Racking Inspection

SITE NAME Acme Logistics Huntingdon	DATE OF INSPECTION 16/02/2024	INSPECTOR Mike Jackson
REFERENCE NUMBER 12345	AREA South West

REF: 26

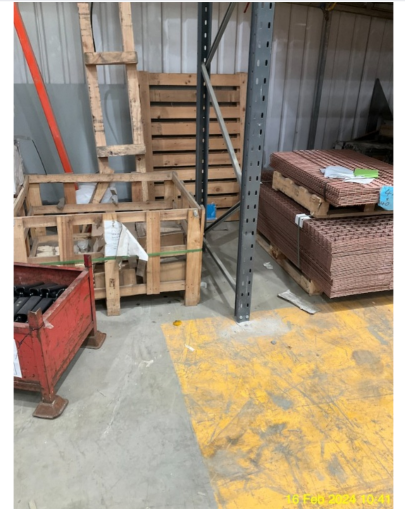
Ref	Location	Product	Fault Type	Recommendations	Risk Factor
11	RAD-R		Horizontal brace L1 - repaint	Repaint	Green
12	RAF-RAG		Damaged front upright	Monitor	Green
13	RAG-RAH		Frame in wrong direction to OEM specification	Maintenance to align	Amber
14	RAG-RAH		Damaged front upright	Replace	Amber
15	Run RB		No load notice in place	Fit new signage	Amber
16	RBA-L		Damaged front upright	Replace	Red
17	RBA-RBB		Damaged front upright	Replace	Red
18	RBA-RBB		Damaged horizontal brace L1	Replace	Amber
19	Run RB		Frame in wrong orientation to OEM specifications - location aisle 7	Instruct maintenance	Red
20	RBB-RBC		Damaged diagonal brace L4	Replace	Amber
23	RBG-RBH		Damaged diagonal brace L4	Monitor	Green
24	RBH-RBJ		Damaged front upright	Replace	Red
25	RBH-RBJ		Damaged diagonal brace L3	Replace	Red
26	RBF-RBG		Damaged front upright	Replace	Amber
